## Attachment B – Proposed Consent Conditions (Updated 12 September 2024)

Note: The base set of conditions presented in this document are as per Attachment B of the evidence in chief of Daniel James Murray dated 3 September 2024. Further updates made to the conditions since this time are shown as tracked changes (additions and ~~deletions~~). **Highlights** indicate matters or cross-referencing which will need to be finalised by Environment Southland.

**Figure 1: Key Features of the Manapouri Lake Control Improvement Project**

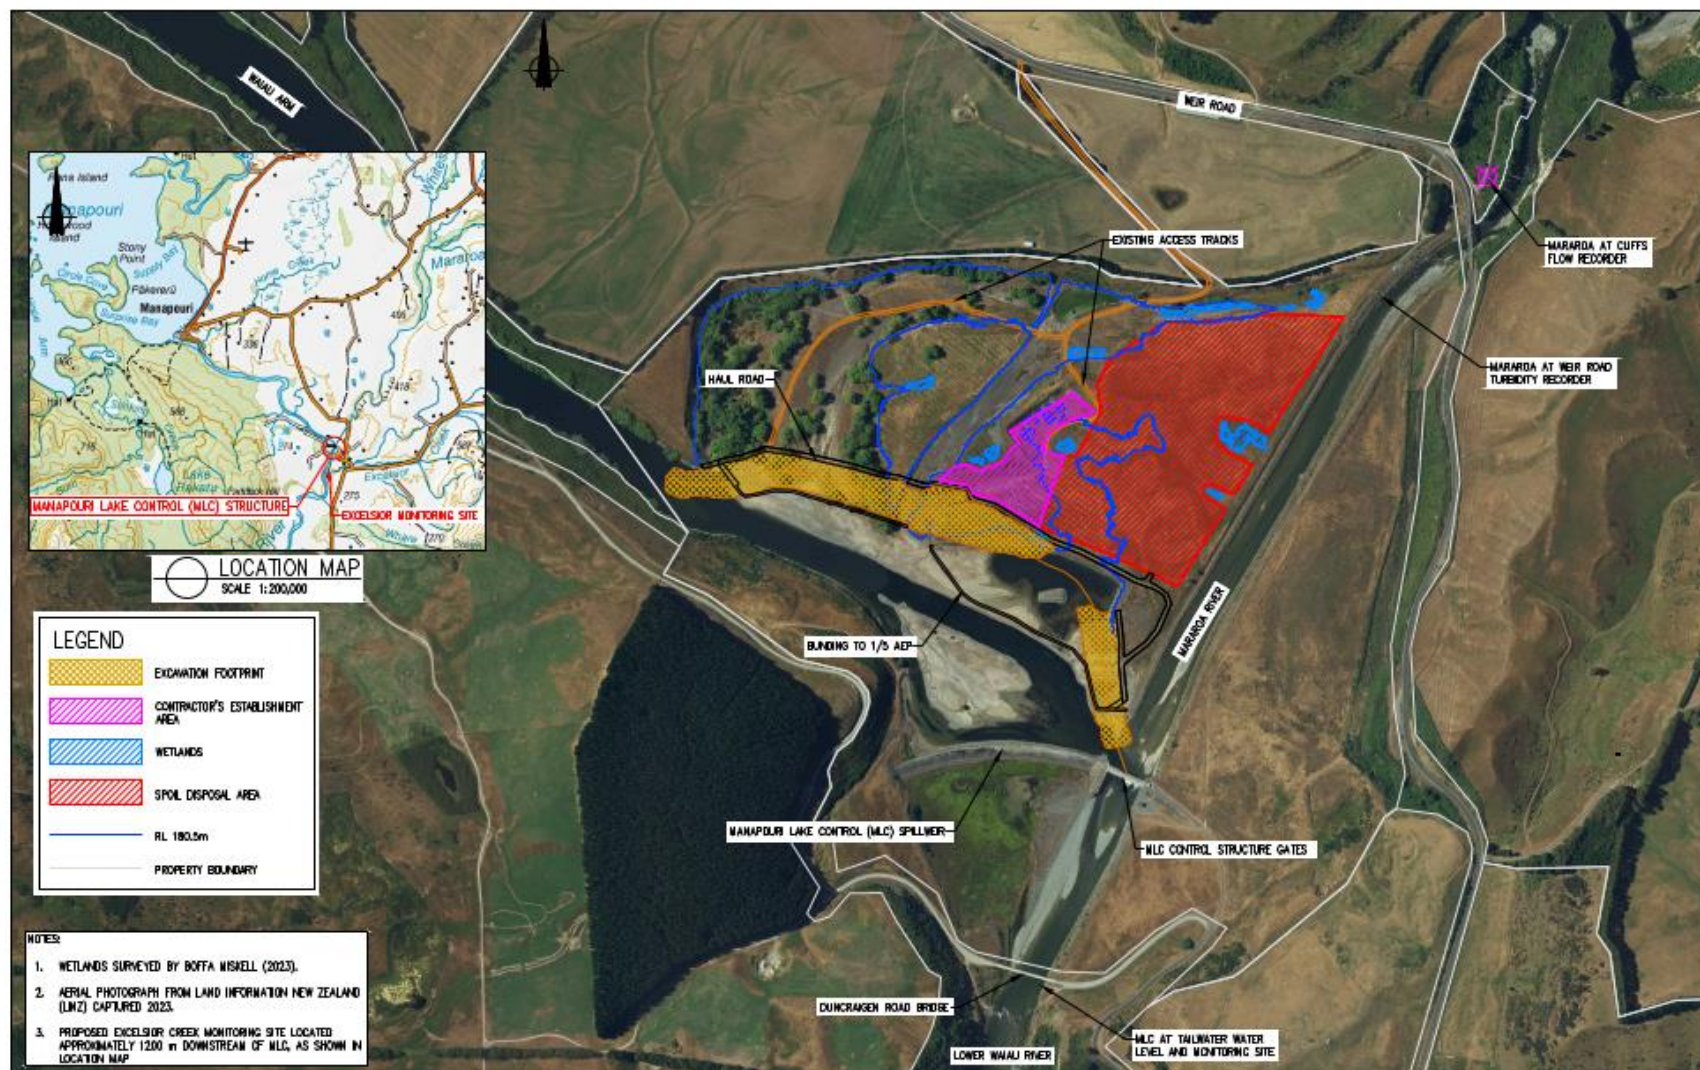
<b>Purpose: To discharge contaminants to water and to land in circumstances where contaminants may enter water.</b> <b>Duration: 35 years</b>	<b>Explanation for proposed revisions made since evidence submission</b>	<b>TAMI comments</b>
<p>5. In the conditions of this resource consent:</p> <ul style="list-style-type: none"> <li>a. “Parallel channel excavation works” means the construction of the parallel channel.</li> <li>b. “Maintenance activities” means those activities, including removal of gravel and bed material, as necessary to maintain the parallel channel, and the existing channels of the Waiau Arm upstream of and around the confluence with the Mararoa River at MLC, in general accordance with their constructed dimensions.</li> <li>c. “Duration of the parallel channel excavation works” means from the commencement of excavation works in the parallel channel to the conclusion of excavation works on the parallel channel including a period ending 5 days (120 hours) after the parallel channel is made fully open to the Waiau Arm.</li> <li>d. The “upstream monitoring site” (UMS) means the existing site monitored by Meridian Energy Limited in the Maraora River at the Cliffs <u>at or about map reference NZTM E1186690 N4935750 and as shown on Figure 1 attached to and forming part of this resource consent</u> <del>[map reference TBC – as per Figure 5.5 of this AEE]</del>,</li> <li>e. The “downstream monitoring site” (DMS) means the existing site monitored by the Southland Regional Council upstream of the confluence of the Excelsior Stream with the Lower Waiau River <u>at or about map reference NZTM E1185763 N4933776 and as shown on Figure 1 attached to and forming part of this resource consent</u> <del>[map reference TBC – as per Figure 5.5 of this AEE]</del>,</li> <li>f. “Total turbidity” shall be calculated by subtracting the mean hourly turbidity reading at the UMS from the same mean hourly turbidity reading at the DMS,</li> <li>g. “Deposited fine sediment” (DFS) means sediment less than 2 mm in diameter, and</li> <li>h. “Baseline DFS” is to be determined in accordance with condition [10].</li> </ul>	<p>Map references for the monitoring sites now included, noting these sites are also labelled on Figure 1 which is proposed to be included in the consent documents.</p>

20.	Any future removal of gravel from the spoil disposal area shall be limited to within the defined 'gravel stockpile cell' as shown on <del>map X in Appendix X</del> <u>Figure 1 attached to and forming part of these resource consents</u> and shall be completed in sequential stages moving from south to north to facilitate progressive rehabilitation.
